CITY OF ALBUQUERQUE

December 1, 2022

**RE: 13312 Hidden Valley Rd NE
Grading and Drainage Plan
Engineer's Stamp Date: 11/14/22
Hydrology File: G23D018**

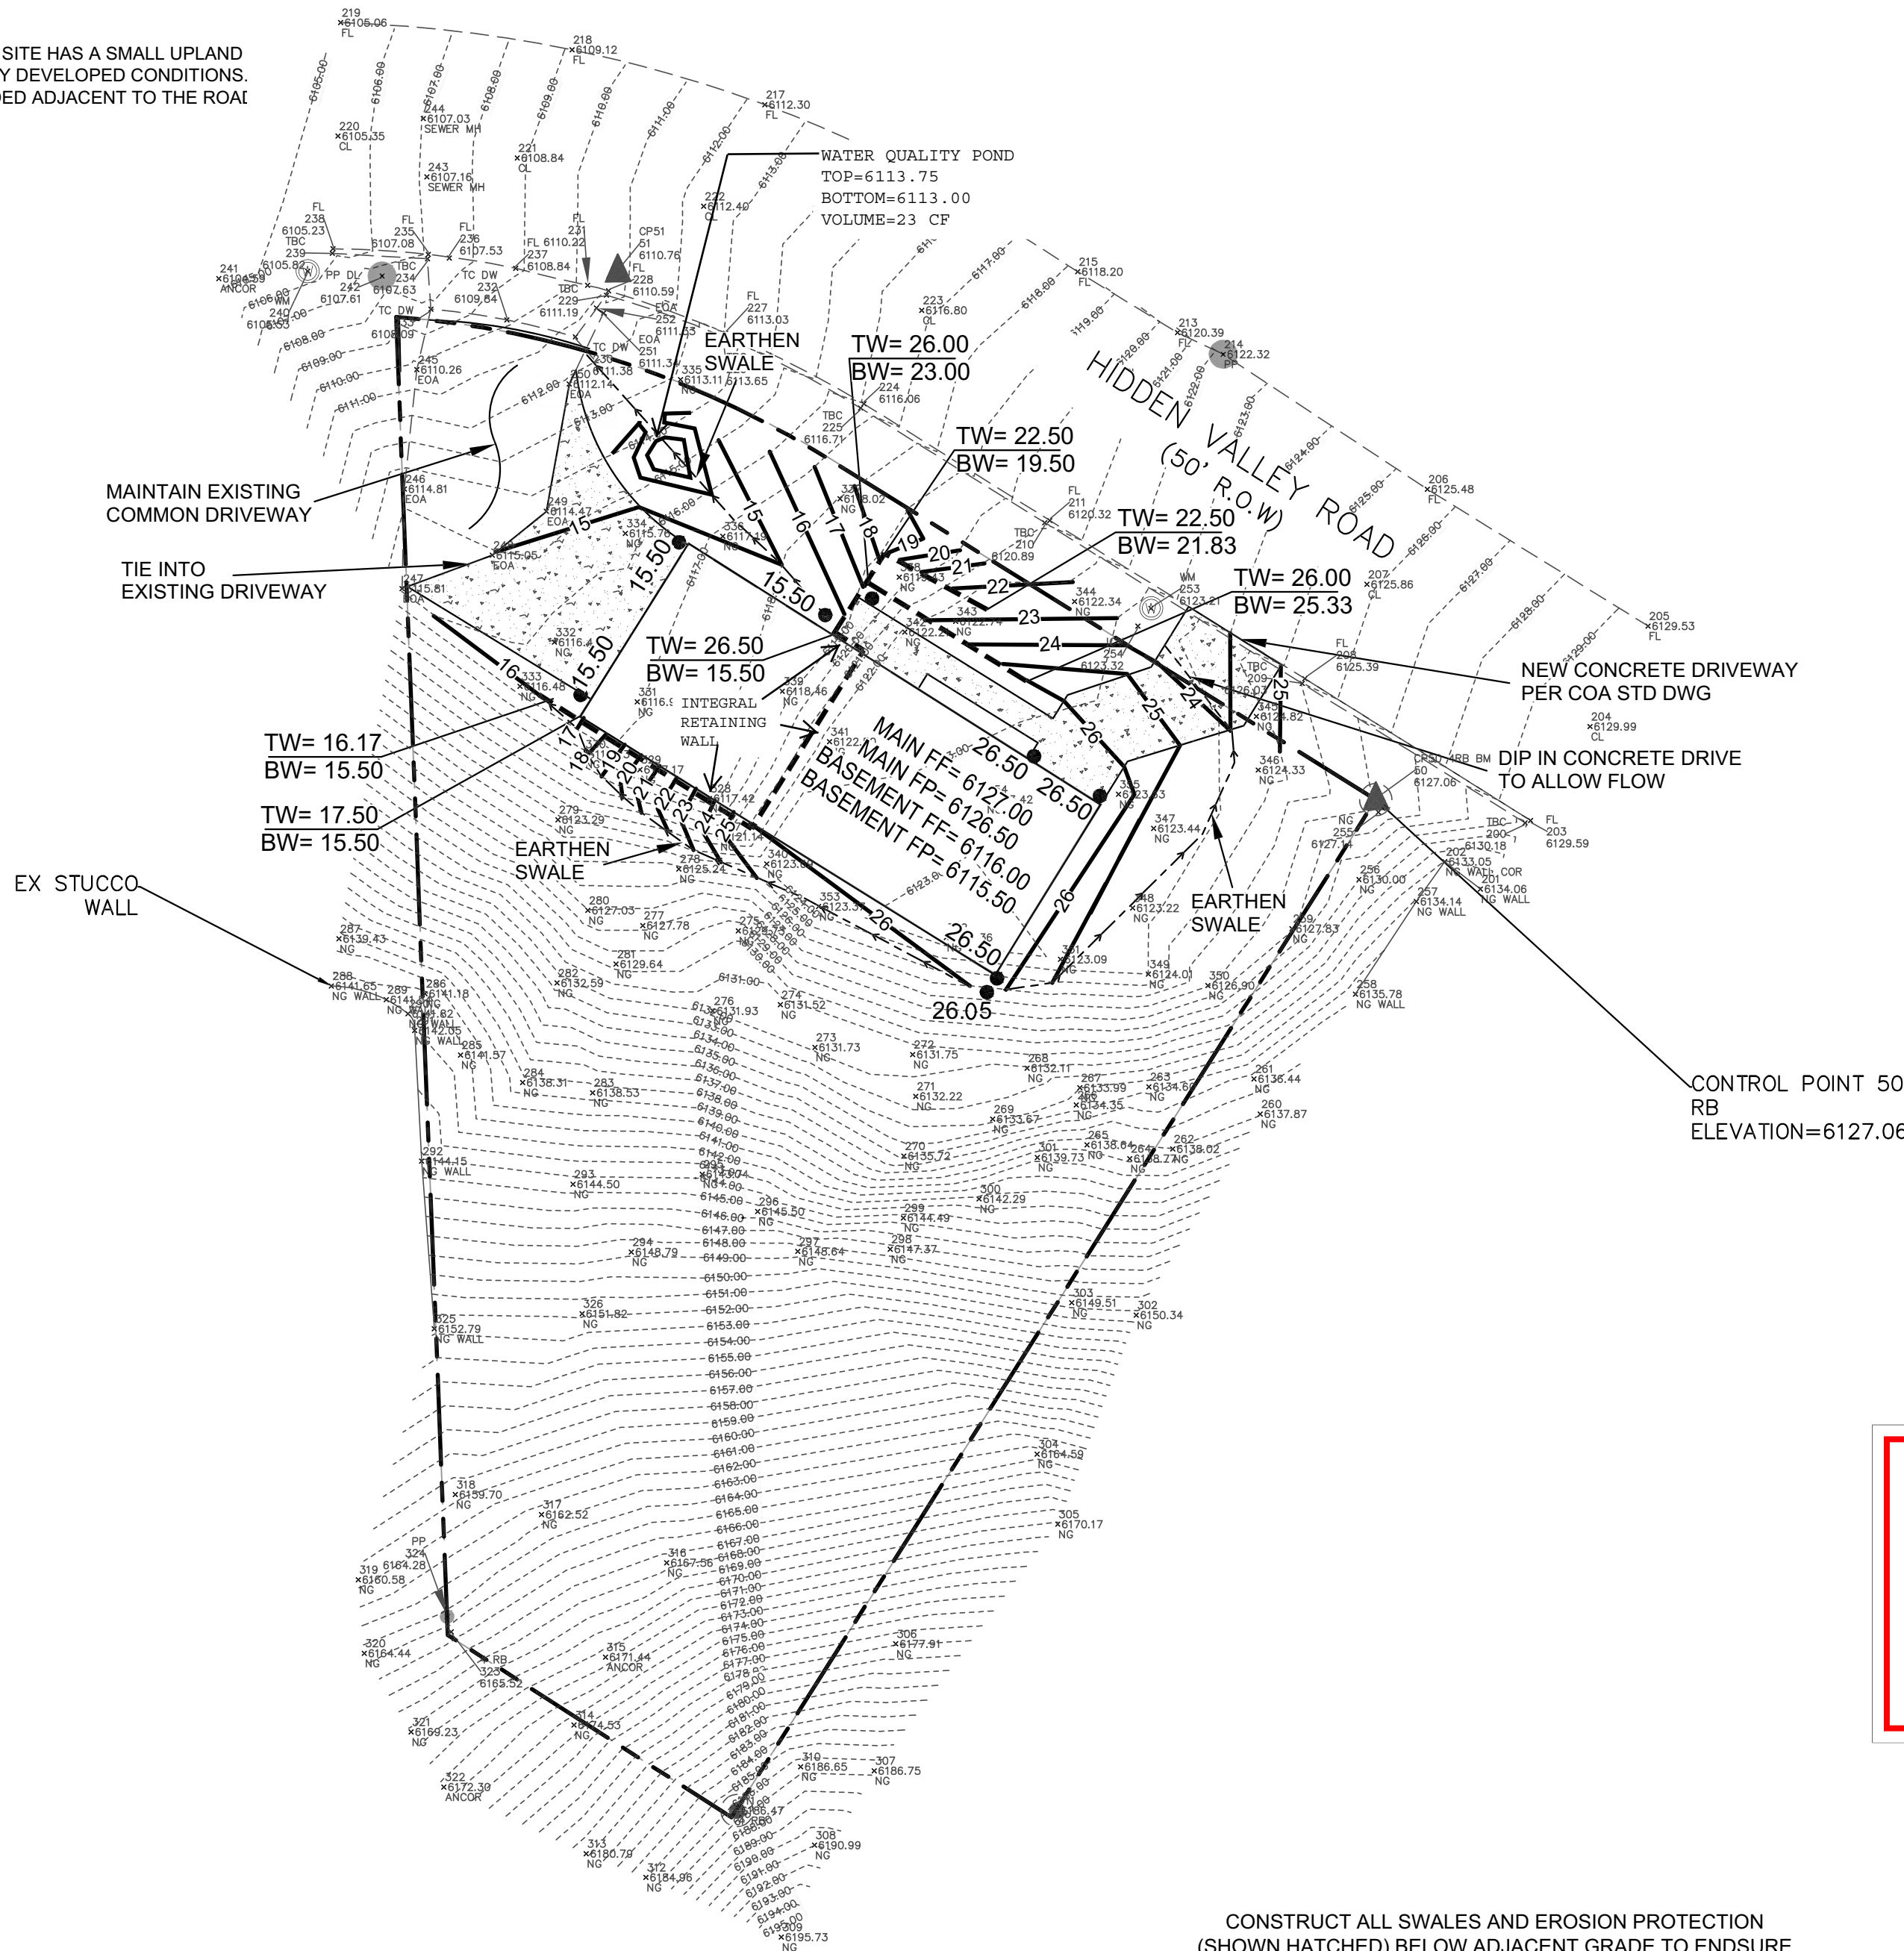
Based upon the information provided in your submittal received 11/15/2022, the Grading and Drainage Plan is approved for Building Permit and Grading Permit. Since this project has storm walls, a pad certification is not needed for this project. Please attach a copy of this approved plan in the construction sets for Building Permit processing along with a copy of this letter.

1. Engineer's Certification, per the DPM Part 6-14 (F): Engineer's Certification Checklist For Non-Subdivision is required.
